**RE: Hayden Gulch Loadout- File No. C-1992-081;
Surety Release Request (SL-3); Adequacy Review**

The Colorado Division of Reclamation, Mining and Safety (Division) received Hayden Gulch Terminal, LLC's (HGT) application for Bond Release SL-3 on September 5, 2023. SL-3 was found complete on September 13, 2023. The following issues regarding the SL-3 submittal must be addressed adequately before the Division can approve the application:

EXHIBIT "9-2"	
SOIL TYPES & TOPSOIL SALVAGE MAP	
TIE-ACROSS HAUL ROAD CORRIDOR	
SENECA 1W MINE	
PEARBODY COAL CO., 1000 SOUTH YALE, FLAGSTAFF, ARIZONA 86001	
DESIGNED BY: G.W.W. & WESCO	SCALE: 1" = 400'
DRAWN BY: J.M.C.	DRAWING DATE: 10-15-84
CHECKED BY: G.W.W.	PHOTO DATE: 7-11-77
REVISIONS	
CONTOUR INTERVAL - 5' WITH 25' INDEX CONTOURS	REV 10-15-84 P.M.W.
5-1-89 5-15-89 7-2-90 8-27-90	REV 5-15-89 D.E.F.
	6-21-91

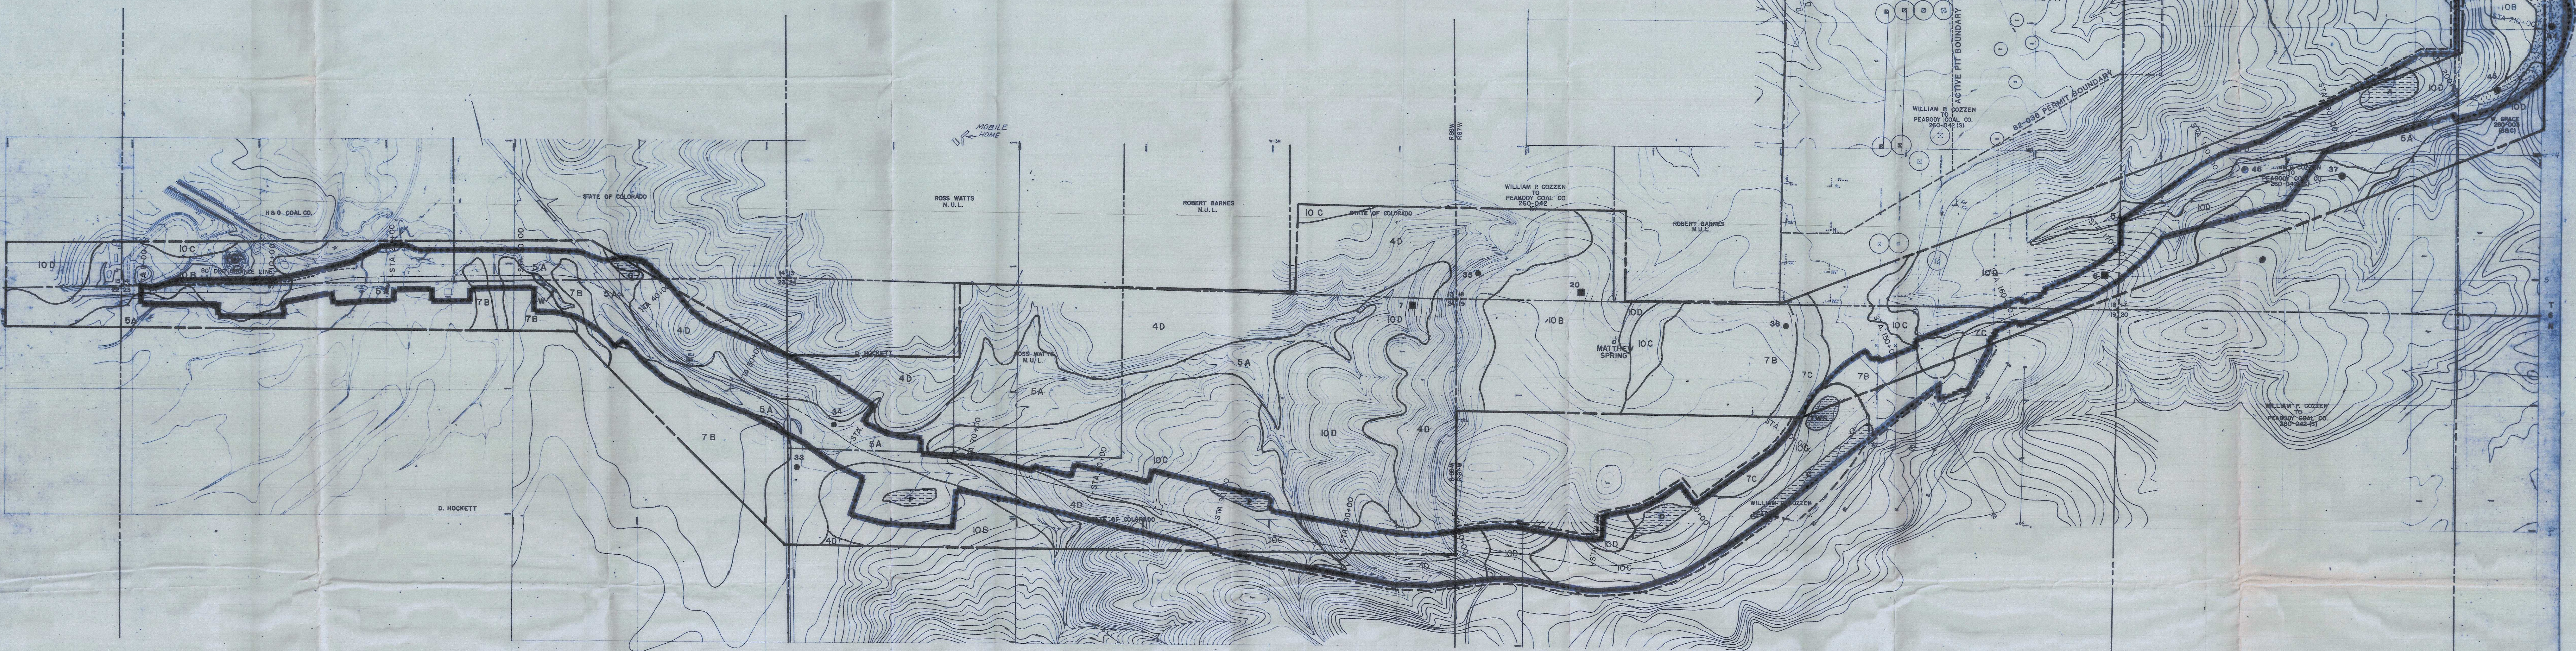
4. The SL-3 Area Delineation Map included with the application shows a stockpile located along the TAHR corridor in the northern portion of Section 19 of T6N, R88W. PAP Exhibit 9-2, Soil Types and Topsoil Salvage Map (attached) identifies this pile as a

temporary waste stockpile. Please clarify for the Division if the temporary waste stockpile has been approved to be a permanent feature and reference the relevant PAP section or revision which includes this provision.

5. Page 3 of the Tab 19 Topsoil Handling Plan only accounts for six topsoil piles to remain as permanent features within the corridor. PAP Exhibits 9-1 and 9-2 label 7 topsoil stockpiles as existing within the TAHR corridor. The Division's PAP file Appendix 17-1 'Permanent Postmine Features' does not include a site map or list of features. Therefore, it is unclear to the Division which topsoil piles have been approved to remain permanently after reclamation. Please submit an updated SL-3 Area Delineation Map which outlines and labels all six permanent topsoil pile features.
6. The Hayden Gulch Loadout currently has one active compliance stipulation, Stipulation No. 9. It states,
